**IEEE 802.11
Wireless Access Method and Physical Layer Specifications**

Title: Proposed Updates to the D1 Draft, Section 3

Abstract: This paper proposes changes to the D1 Draft to reflect the resolution of comments on Section 3 arrived at during the March 95 meeting as shown in the companion document 95/64 R1.

Action: Adopt the changes in this paper to update the relevant portions of P802.11/D1

Figure 3-3: Example of SDE Transmission Procedure

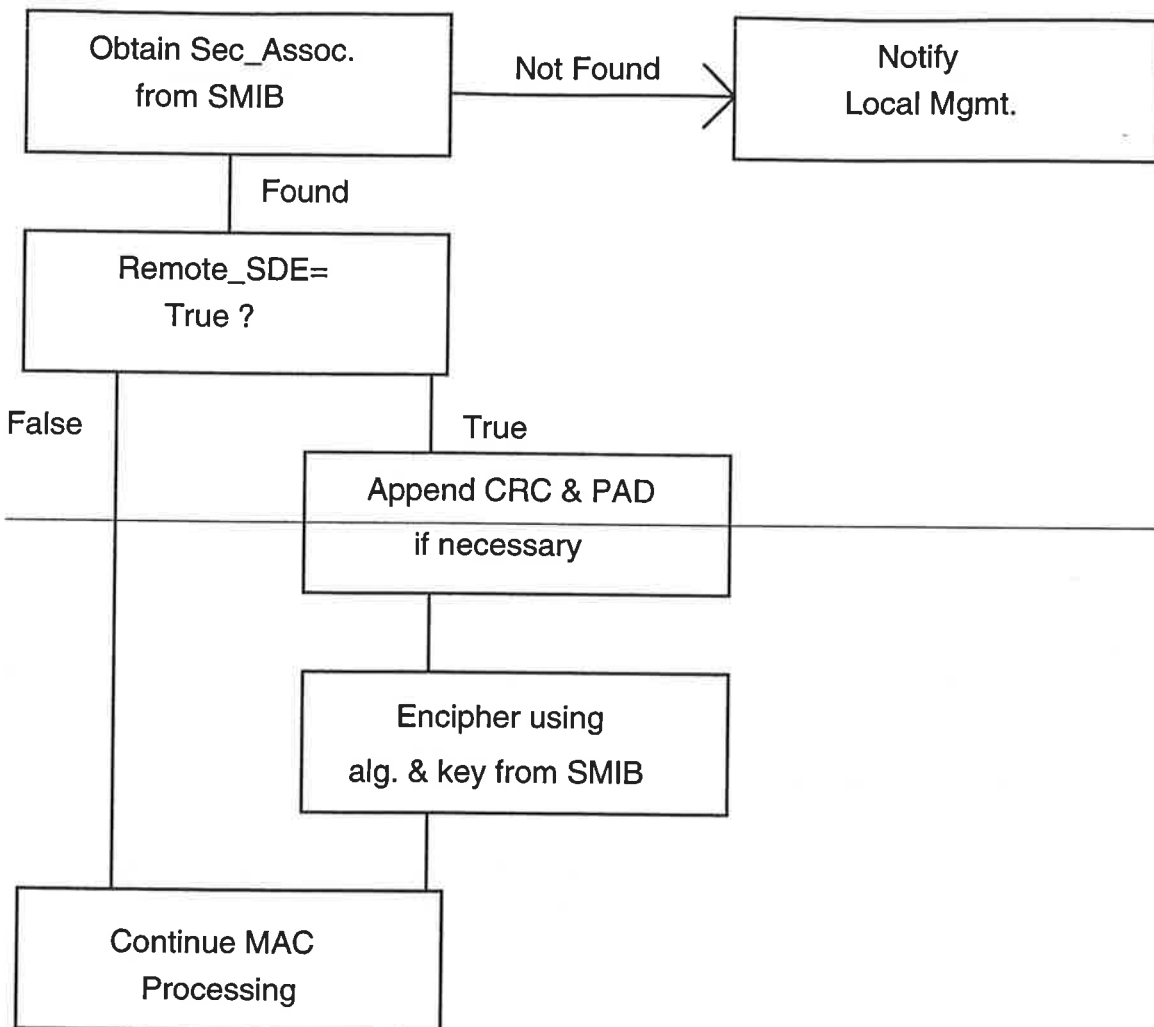
~~Transmission procedures. The transmission procedures are those involved in processing an UNITDATA request. The functions are represented as a flow chart shown below, (Object values are contained in the SMIB).~~
